North Roseville Specific Plan Phase II

Final Subsequent Environmental Impact Report SCH #98112063

City of Roseville Planning Department

These changes are illustrated on the "T" Intersection Alternative Alignment Option Figure 2-1 and Land Use Table 2-1.

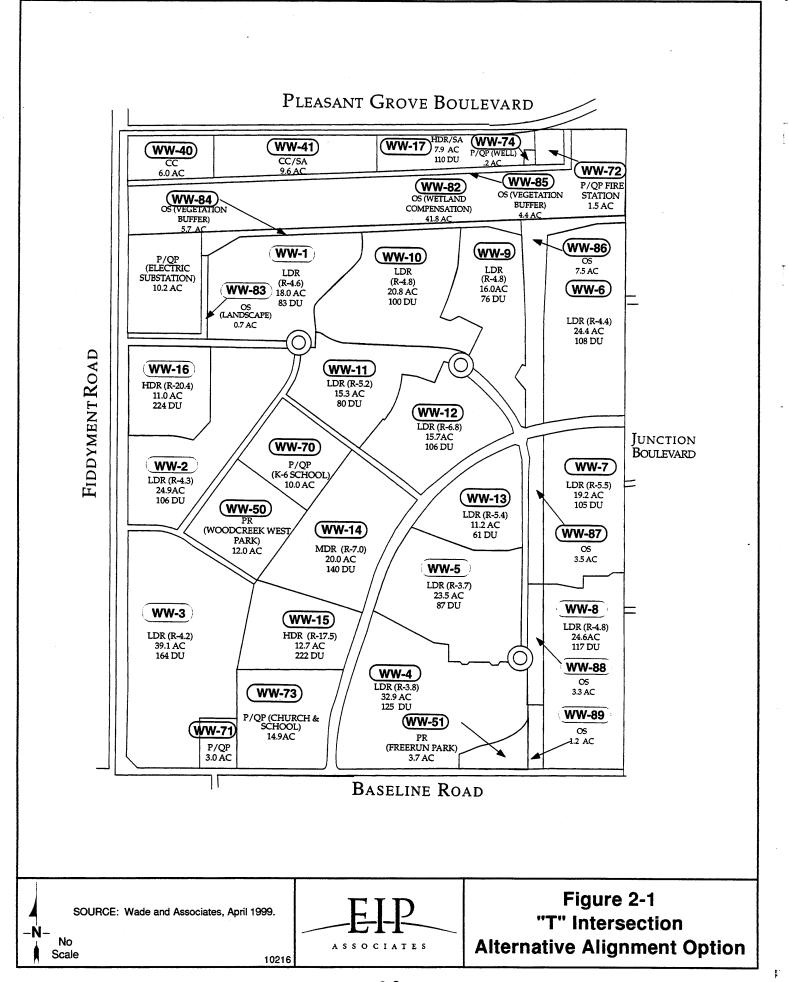
A traffic signal at Junction Boulevard and the collector street within Neighborhood D which provides access to the elementary school has been added to the initial phase of development.

An option of a "T" intersection of Junction Boulevard into Baseline Road is included in the Specific Plan. Under that option the changes include:

- A reduction in right-of-way acreage.
- A reduction in acreage in the parcel dedicated for the school administration.
- Slight increase in acreage for low density residential with a minor decrease in unit density.

Under this option there would be no change in the number of residential units included under the proposed project. The only changes would be a slight reduction in land set aside for road right-of-way and a slight reduction in acreage for the parcel dedicated for the school administration offices resulting in a slight increase in acreage for low density residential. These changes would not result in any changes in the environmental analysis, including the traffic analysis, prepared for the proposed project.
